Re: Petition 1535 – Ledyard Junction to Mystic Substation

Response to CSC-01 Interrogatories dated November 9, 2022  
Set 01 – Questions 1-29

**Date Filed:** November 22, 2022

**Request from:** Connecticut Siting Council

Structure 8388: Woodpecker Damage and rotted pole

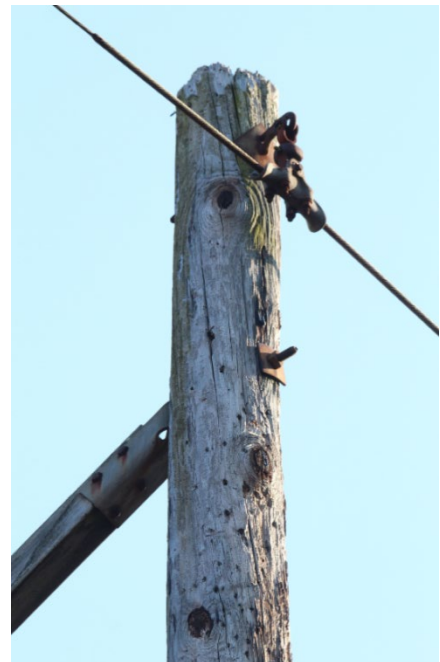
Provide sample photos of the asset conditions associated with the structures to be replaced.

Structure 8370: Woodpecker Damage

Structure 8374: Hollow Pole and severe woodpecker damage

Structure 8387: Woodpecker Damage and rotted pole
